**RE: Review and Commentary of Green Ridge Landfill Documents.**

I have completed the review of several of the technical documents associated with the permit application by Green Ridge. I did this with the aim of answering the attached "Questions for Geologist" that CCLA submitted to me addressing its concerns with the adequacy of the science conducted for the permit. Because my expertise is in geology, I focused on the *PTA Attachment XI Hydrogeologic and Geotechnical Report* and the *PTA Attachment VII Landfill Impact Statement*.

Figure 2 illustrates the location of the site relative to the mapped epicenters within the CVSZ.

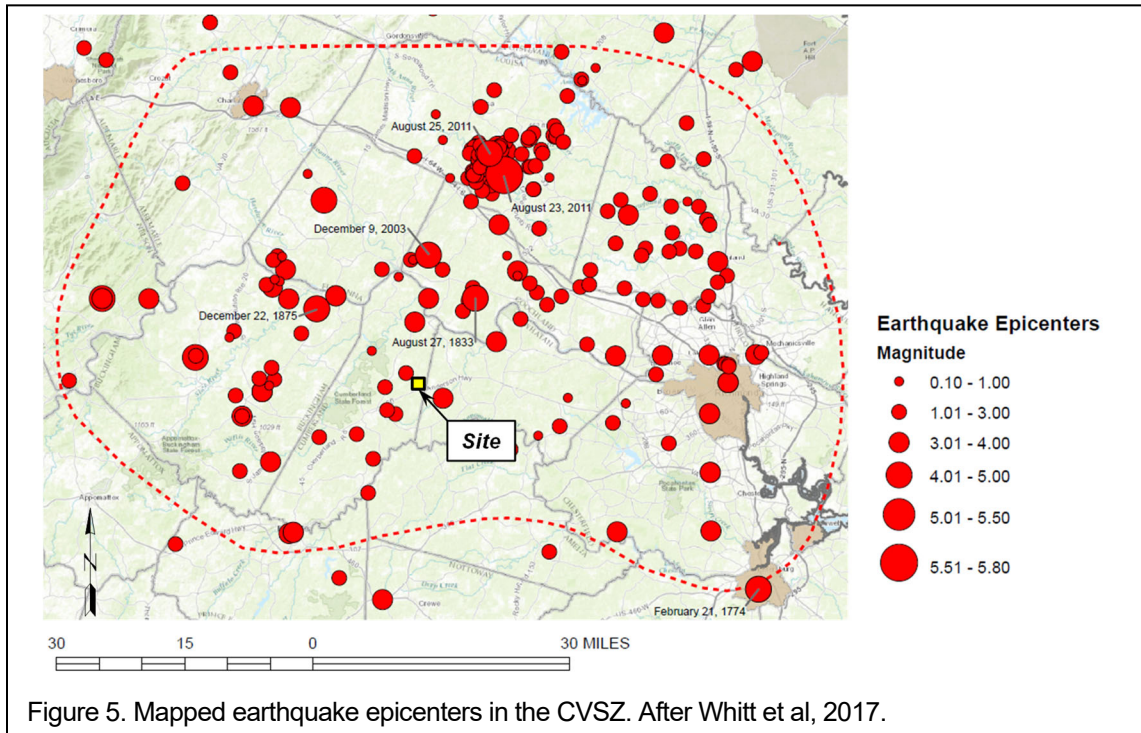
My main concern is what can happen to the liner during an earthquake. Virginia contains two zones that have a history of seismic activity, the Giles County Seismic Zone (GCSZ) and the Central Virginia Seismic Zone (CVSZ, Fig. 4). Both of these seismic zones have a history of significant earthquake activity, including the largest recorded earthquake in Virginia history (Mag 5.8) that took place in Louisa County in 2011 (Figure 5). Note that Cumberland County is primarily located in the hottest part of the zone, as well as most of the counties adjoining it.

So, what can happen to a landfill liner resting on rock with tons of waste atop it when the earth begins to shake? There will be a significant difference between the stiffness and density of the waste and that of the bedrock, which will result in disparate shaking of those two materials during an earthquake. Because the rock is very stiff, it will move back and forth very little, especially when compared to the waste. The waste will have very low stiffness, so it will experience far greater shaking. The disparate shaking of those two materials will likely put shearing stresses on the liner. With the liner in contact with the rock, it seems probable that this shearing will take place over rock points and edges, and that this will lead to tears and punctures. On the other hand, if the liner were to rest on a softer material such as compacted clay, the stiffness differential between the clay and the waste would be significantly lower. This will result in a lower difference in shaking and corresponding lower shear stress on the liner. Moreover, as the liner moves relative to the compacted clay beneath it, there will be no sharp edges save the occasional rocks or debris.

- 1) Though the DEQ landfill regulations allow a landfill to be constructed with the liner resting on bedrock, future seismic activity is likely to result in shearing forces on the liner from the differential shaking between the waste and the bedrock. A liner resting on a softer material such as compacted clay will experience less shearing force from smaller differential shaking.

Figure 7. Approximate site location relative to locally mapped faults in the CVSZ. After Whitt et al, 2017.

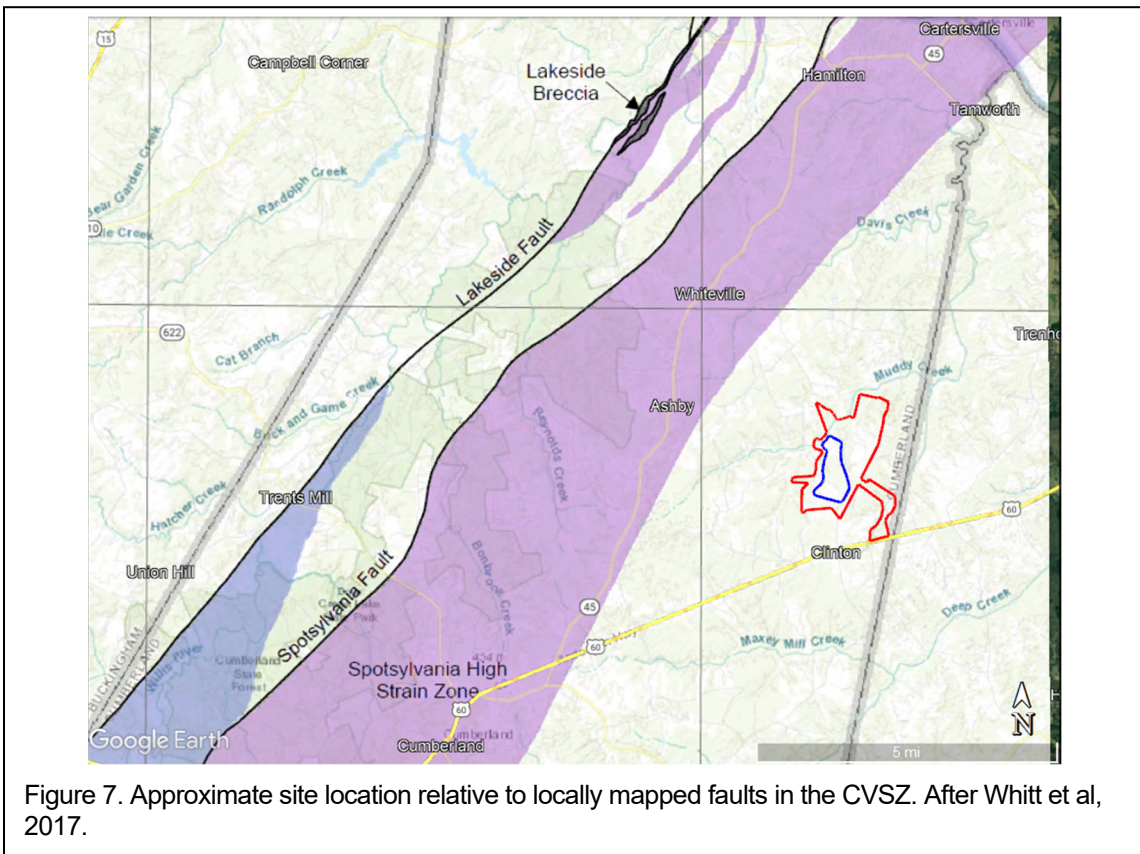
Figure 7 contains a portion of the previous fault map at a larger scale illustrating the approximate location of the proposed landfill site relative to the mapped faults. Though there is no evidence that these faults are currently active, they were once active and will have fracture zones parallel to them, as well as fracture zones in other orientations depending on the principal directions of ancient tectonic stresses. My point is that it is possible that similar faults are present under the site that have gone unseen. It is highly likely that existing fracture zones associated with the known faults exist beneath the site as we will discuss later in this section. These faults and fracture zones are highly likely to be exerting influence on the local hydrogeology. Seaton and Burbey came to the conclusion that not only do fault zones have an influence on local hydrogeology, but they may actually “dominate the flow characteristics of a region.” (2005).

Note that Set 3 has a similar orientation to that of the faults on Figure 7. I measured many of the fault orientations and found that the average bearing is 342 degrees, which falls in the upper half of Set 1. It is possible that these fractures were formed in association with the faulting.

- 2) The *PTA Attachment VII Landfill Impact Statement* and the *PTA Attachment XI Hydrogeological and Geotechnical Report* ignore certain important aspects of the hydrogeology of the site. Specifically, the reports ignore the possibility that faults, fracture zones, and/or diabase dikes exist beneath the site and are exerting influence on the local hydrogeology. Moreover, the reports ignore the fact that groundwater flow in the Blue Ridge and Piedmont is usually anisotropic because of the influence of mineral banding, foliations, and fracture zones. These features can dominate the groundwater flow in the Piedmont and Blue Ridge yet have thus far not been recognized in the science.

Figure 8. A portion of the published geologic map of the area.

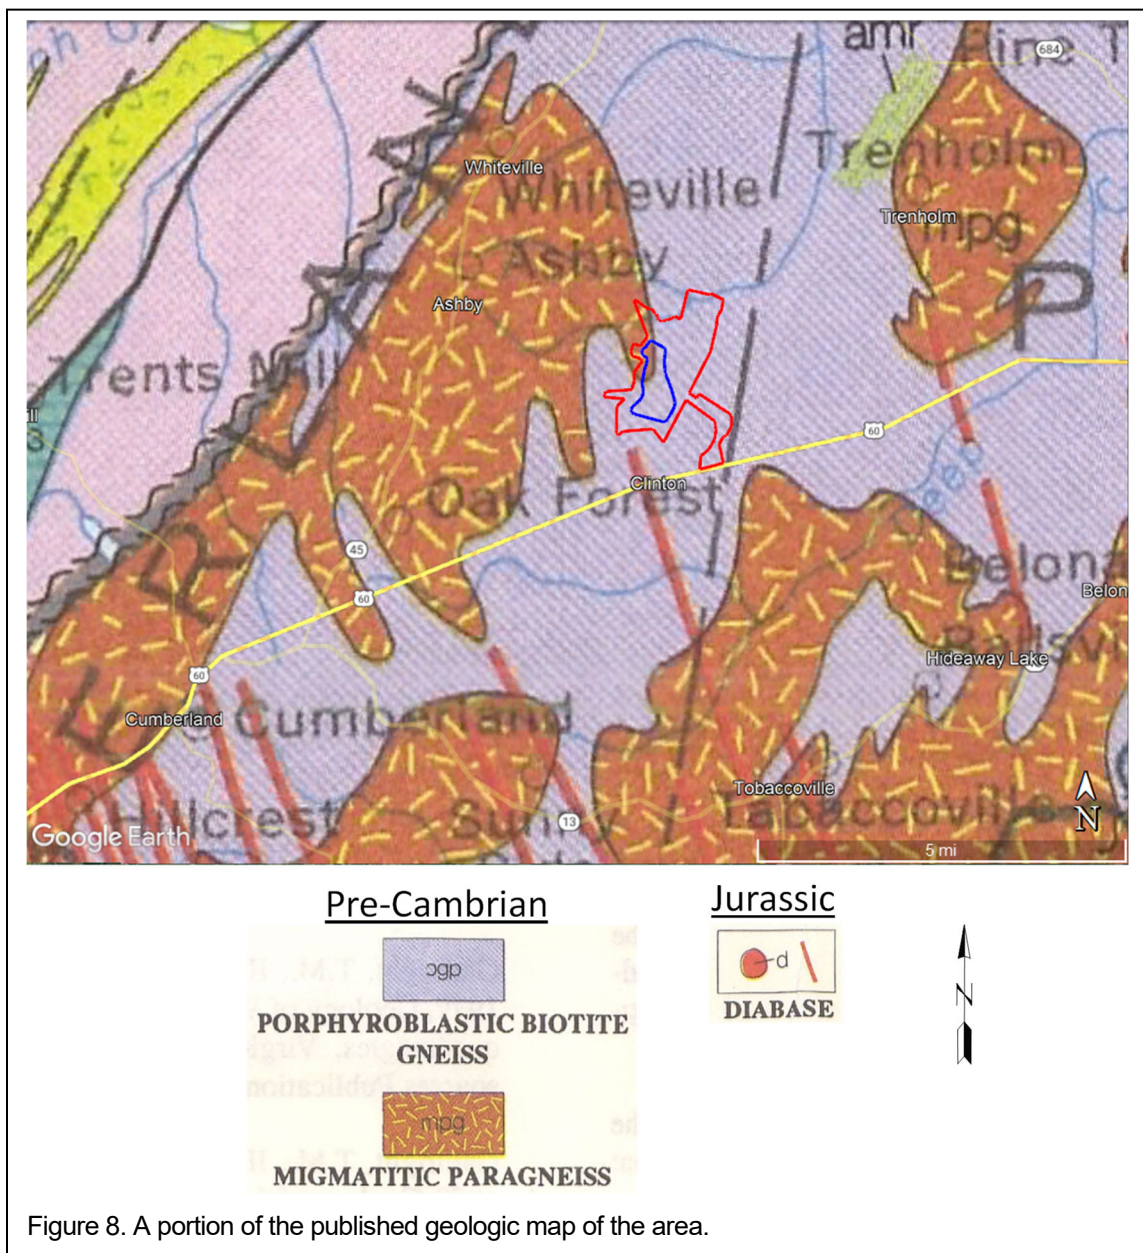
Even at 1:500,000 scale the geologic map reveals many diabase dikes in the vicinity of the site. These dikes are younger than the surrounding rocks because the dikes were formed when diabase magma pushed its way up into prominent fractures of the existing rocks. I will come back to this point later, but note that the orientation of most of the dikes in Figure 8 is somewhat west of north.

Moreover, note how similar the orientations of the diabase dikes in Figure 8 are to the orientation of Set 1 in Figure 12. I measured the orientations of the diabase dikes to have an average bearing of 342 degrees, which is within the range of Set 1. It is possible the diabase dikes were formed by exploiting some of the fracture zones in Set 1, and there may be diabase dikes that exploited fractures under the site that have gone unmapped. This is important because it has long been common knowledge to hydrogeologists that drilling a water supply well next to a diabase dike is very likely to result in a high production well because of the bedrock fracturing associated with the dike. These dikes facilitate groundwater movement along their edges.

Figure 11. Shaded relief map depicted the site and local fracture traces.

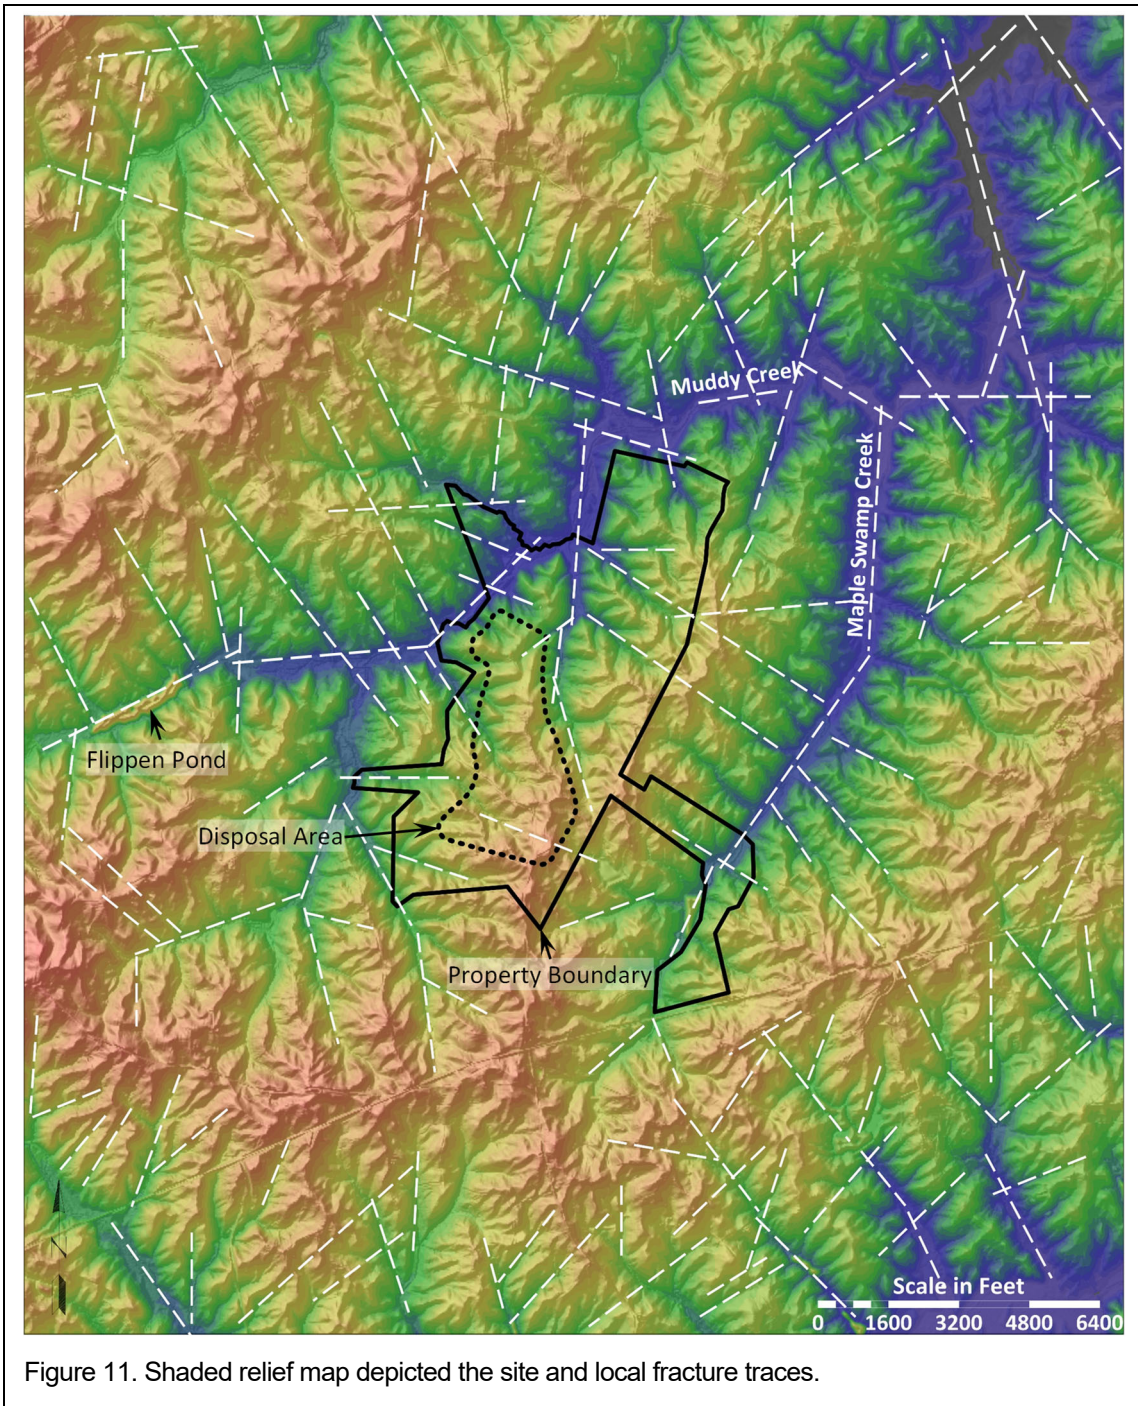
I performed a fracture trace analysis for the site and surrounding area using shaded relief mapping constructed from publicly available LIDAR data. Fracture trace analysis uses local topography to infer the orientations of underlying fracture zones. The premise is that fracture zones in rocks present more surface area to weathering, so they will often be expressed in the topography as relatively long, straight, topographic draws. Examining the shaded relief map in Figure 10 we see drainage patterns at various scales with the most prominent represented by Muddy Creek and Maple Swamp Creek. Evidence of fracture-controlled drainage is clear in Maple Swamp Creek, which is comprised of only two segments that are very straight. We can also see that the tributaries and drainages into Maple Swamp Creek are also characterized by very straight topographic draws. At first glance Muddy Creek gives the opposite impression, an impression more of a meandering stream. However, on close examination we can see that this apparent meandering is actually the stream intersecting joints at various angles as it makes its way downstream. Figure 11 is the shaded relief map with my interpreted fracture traces superimposed as the white dashed lines.

This analysis suggests that groundwater movement in fractured bedrock will be facilitated in the general directions of these fracture trace sets. This is not to say that groundwater cannot move along other fractures in other directions, but that there will be a propensity for groundwater and dissolved contaminants to move along major fracture zones. It is noteworthy that many of these fracture traces pass through the landfill property and into the proposed disposal area.

As discussed, Maple Swamp Creek and Muddy Creek are two major stream systems that bracket the site, with Maple Swamp Creek approximately paralleling its eastern boundary and Muddy Creek on its north-western and northern sides. Maple Swamp Creek appears to exploit two long fracture traces, one from Set 3 (upstream) and one from Set 2 (downstream). Expanding on my earlier observation that Muddy Creek does not actually meander much but rather intercepts fractures at various orientations, examine Muddy Creek on Figure 11 in the area of Flippen Pond. Flippen Pond was built on a stream segment that appears to be a fracture zone in Set 3. It then turns due east, which is not a dominant

- 7) It is my opinion that resistivity imaging data should be collected to evaluate the presence of potential faults, fractures, and/or breach zones within the proposed disposal area.

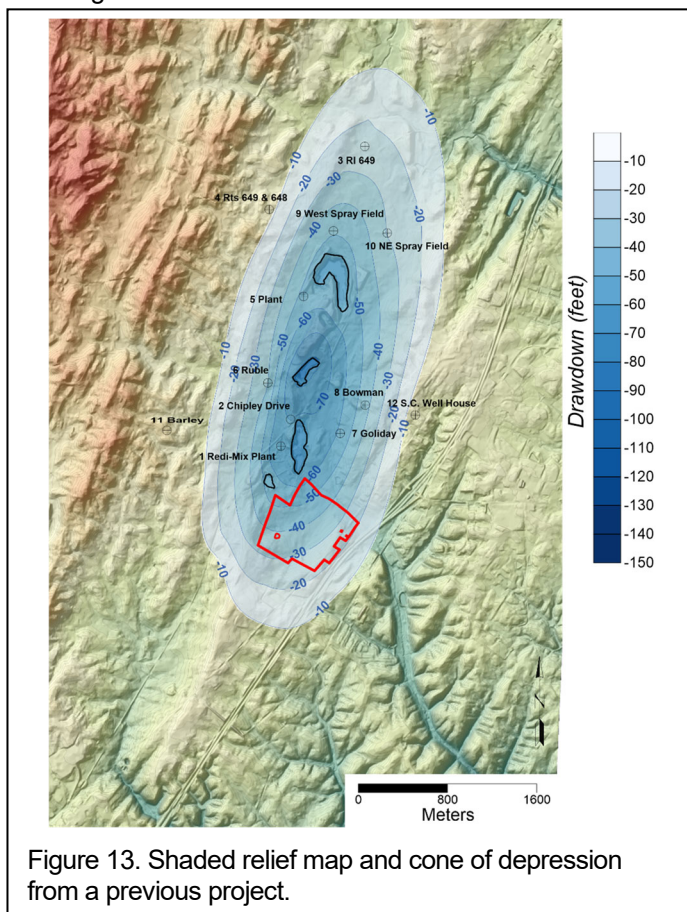
The rose diagram reveals three major groupings or “sets” of fracture traces, which I have numbered randomly in Figure 12. Set 1 centers on a bearing of about 330 degrees, Set 2 on a bearing of about 15 degrees, and Set 3 on a bearing of about 50 degrees. Note that the diagram is symmetrical about the horizontal axis and that those clusters on the top half are mirrored on the bottom half.

Figure 17. Example resistivity sections illustrating fracture zones in crystalline rocks.

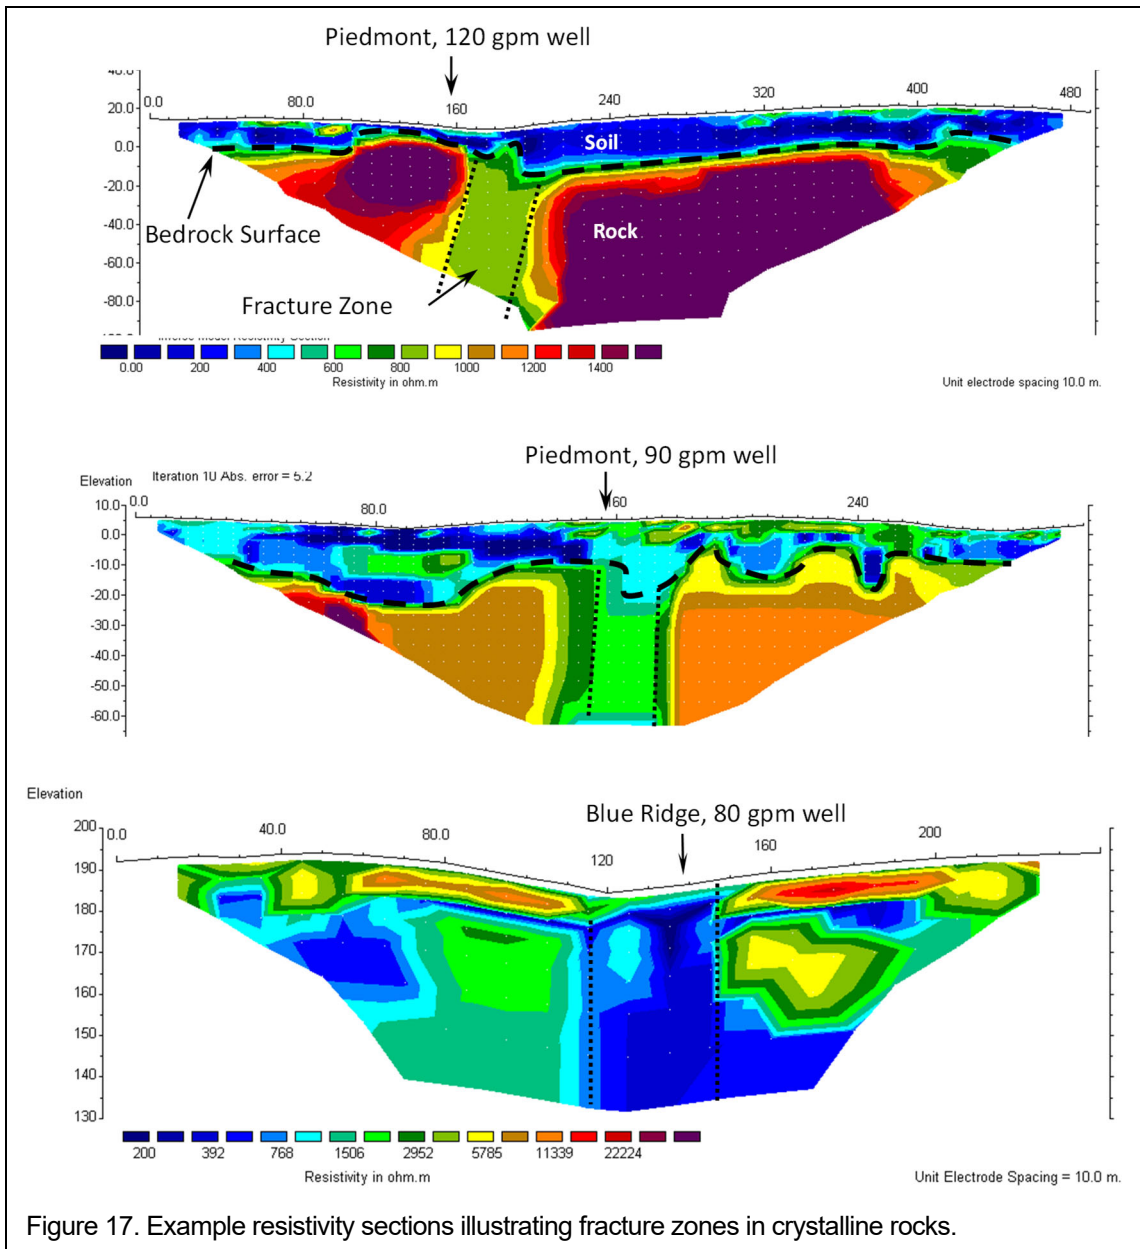
But Seaton and Burbey's research and my consulting experience do not bear this out. In fact, many resistivity sections in the Blue Ridge and Piedmont contained significant low-resistivity features within the bedrock that we interpret as water-bearing fracture zones. We used this interpretation many times to find high-production water wells, or to identify locations for monitoring wells to intercept contaminated groundwater flowing through fractures. Figure 17 contains several resistivity sections from such work along with the geologic province and yield of the well drilled into it.

Contrary to the previously accepted aquifer model, modern research and my consulting experience bears out the conceptual model as put forth by Seaton and Burbey (2001), in which two or more distinct aquifers exist in the crystalline rocks of the Blue Ridge and Piedmont. A shallow water table aquifer exists in the soil, weathered rock, and shallow bedrock fractures, but deeper fractured rock aquifers exist at depth that are associated with ancient faulting and tectonic stresses. These two aquifers are separated by low-permeability rock with low fracture density which confines the lower aquifer, and the two aquifers are intermittently connected through breach zones in the confining unit. This conceptual model is encapsulated in Figure 18. It should be noted that though this diagram depicts the breach zone as occurring in a topography low area, they are not necessarily associated with any topographic features.

- 3) DAA has oriented its narrative of the hydrogeology to that of an outdated hydrogeologic model that is consistent with their statement that “Flow of groundwater in bedrock primarily occurs in the upper weathered portions, and not the underlying, less weathered and more competent portions.” However, this is not consistent with the description of some of the domestic wells in the area which draw their water from deep, confined fractures. Moreover, many of these domestic wells produce as much as 50 gpm, indicating that the aquifer from which they are

- 4) The geologic investigations to date have only considered the shallow groundwater, and no borings or corings have been conducted to the depths equivalent to the bedrock wells surrounding the site. Therefore, the geology has not been characterized relative to the domestic water supplies in the area. To do so, it will be necessary to drill wells up to depths comparable to the domestic wells and to design pump tests that will evaluate a) the potential for hydraulic communication between the shallow and deep aquifers (including evaluating of natural vertical gradients), and b) the potential for communication between the site and nearby domestic wells. Therefore, I recommend that the pump tests be conducted near the boundary of the property close to the clusters of domestic wells described in the LIS. This will allow domestic wells within 500 feet of the site to be monitored during the pump tests.

Figure 19. Schematic diagram illustrating the relationship between local (blue), intermediate (red), and regional (green) flow systems. Modified from Fetter (1988), Tóth (1995), and Tóth (2008).

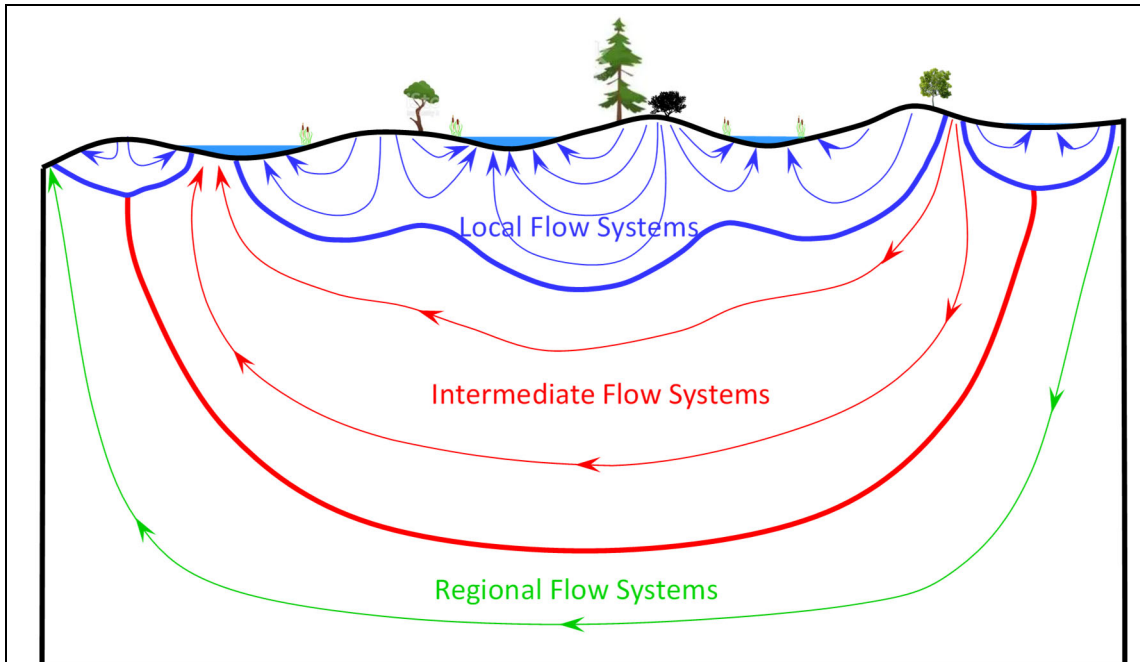
There are multiple occurrences in the hydrogeologic report and LIS where DAA uses language about surface water streams as a barrier to groundwater flow. While this principle has been accepted as common knowledge among geologists for generations, it applies primarily to shallow groundwater flow. Surface water streams in no way act as barriers to deeper, larger flow systems. It has been accepted by hydrogeologists for decades that flow systems occur at varying scales and that larger-scale flow systems can by-pass local streams. Figure 19 is a schematic diagram that has been modified from Fetter (1988), Tóth (1995), and Tóth (2008). There is no information that would preclude the possibility that the site is part of local, intermediate, and regional flow systems as depicted here.
